Re: CECP Data Adequacy Supplement A, 07-AFC-6

**Subject: Carlsbad Energy Center LLC – Carlsbad Energy Center Project AFC (07-AFC-6):
Data Adequacy Supplement A**

In Response to Data Adequacy Review
of the
Application for Certification
for the
CARLSBAD ENERGY CENTER
PROJECT
DATA ADEQUACY SUPPLEMENT A
(07-AFC-6)

12
FIGURE TSE1b-5
NE-LINE DIAGRAM
INCINA POWER STATION UNIT 4
PRE-PROJECT

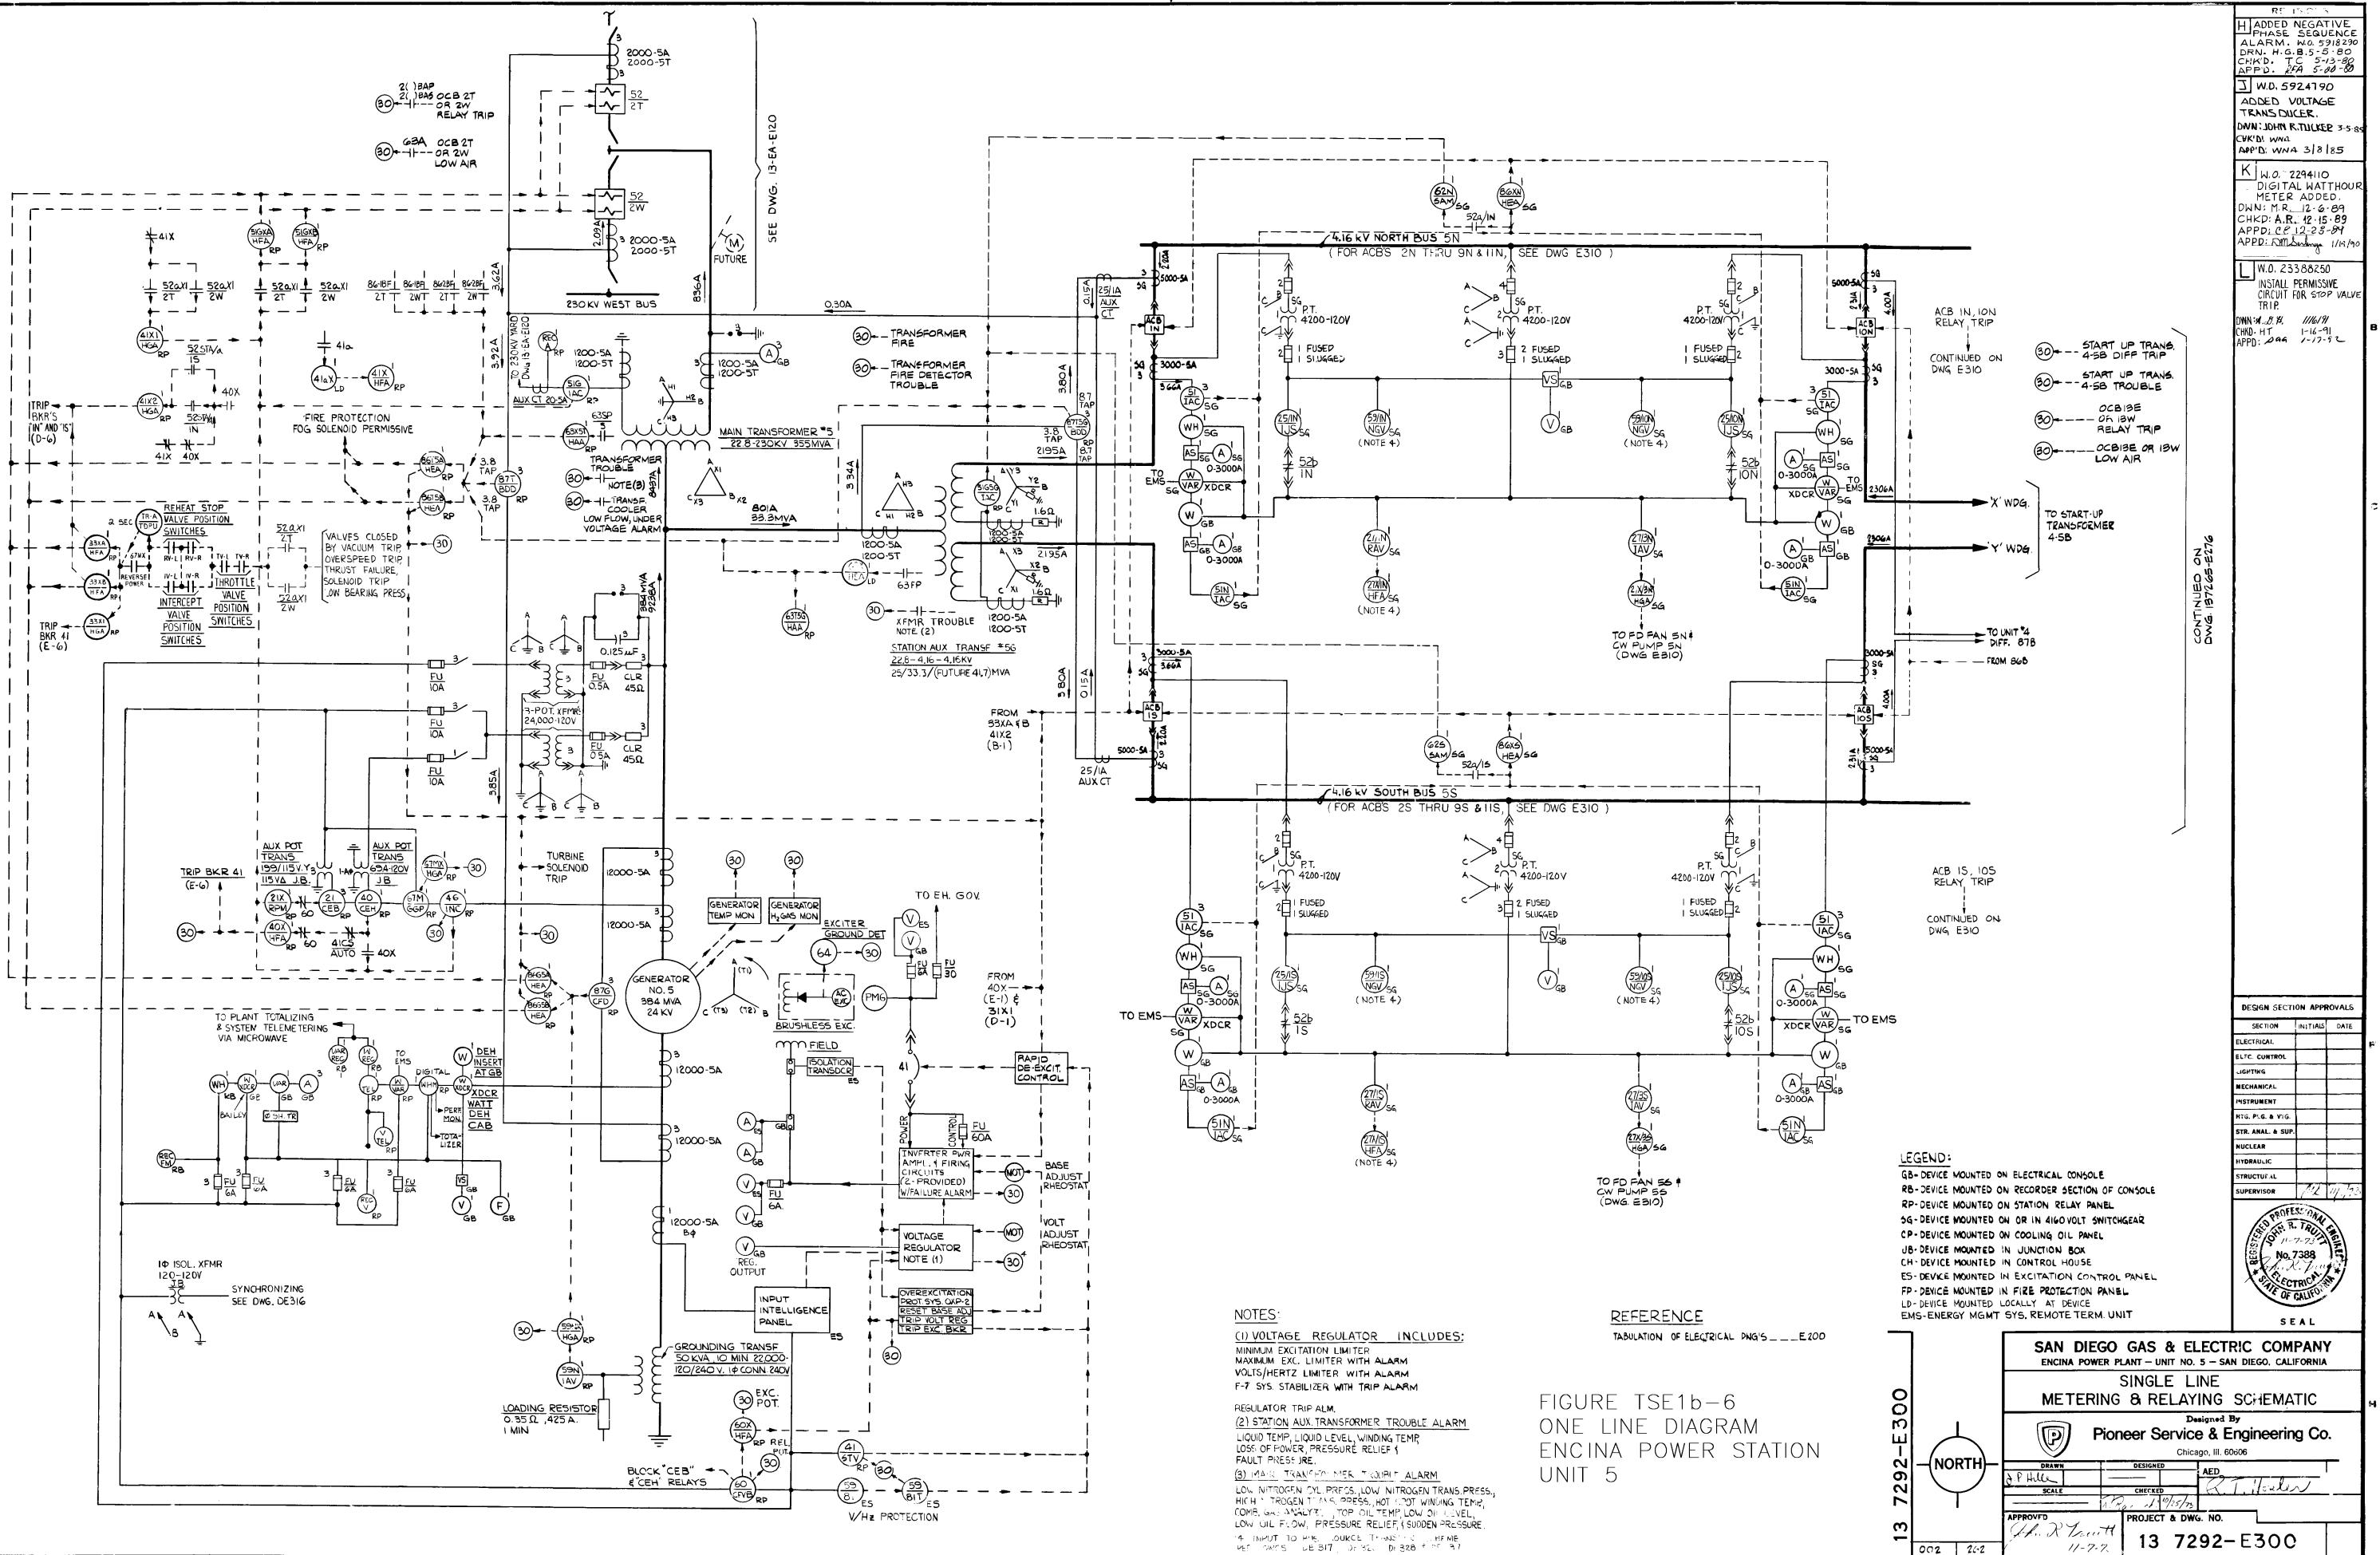
b. Also provide a one-line diagram showing the existing Encina generator units and pre-project existing 138 kV & 230 kV Encina Switchyards with their configurations, buses, breakers with the existing transmission outlets.

Response— The requested figures are provided as Figures TSE1b-1 through TSE1b-7 and are described in the revised text that is attached.

Figures TSE1b-5, TSE1b-6 and TSE1b-7 show the one lines of the existing Encina generating units 4, 5 and EGT-1.

FIGURE TSE1c-3 230kV Line Pole Cross-section Tangent Pole

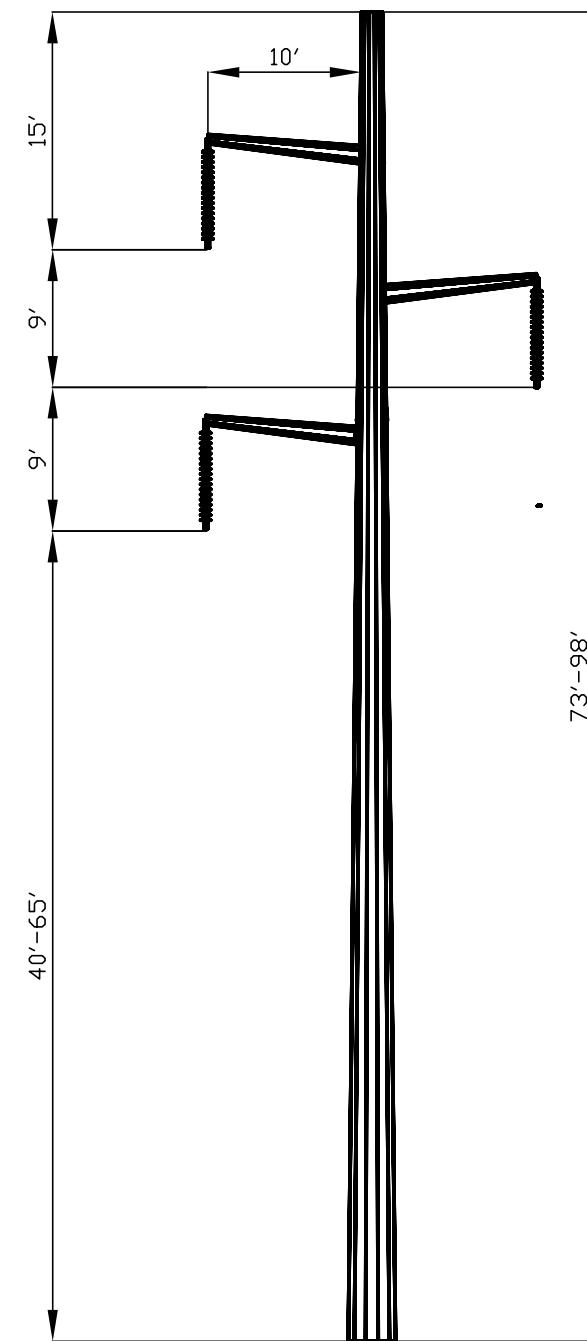
c. Provide a physical layout drawing of the CECP switchyards or the post-project Encina Switchyards showing all major equipment and transmission outlets.

- Figure 3.3-2 Figure TSE1c-3 shows a cross section of the 230-kV tangent pole with phase configuration change from the previous pole.
- Figure 3.3-3 Figure TSE1c-4 shows a cross section of the double-circuit 138/230-kV dead-end angle pole, before the lines cross the existing railroad track at approximately perpendicular to the track. A minimum of 34 feet of clearance above the railroad track will be maintained.
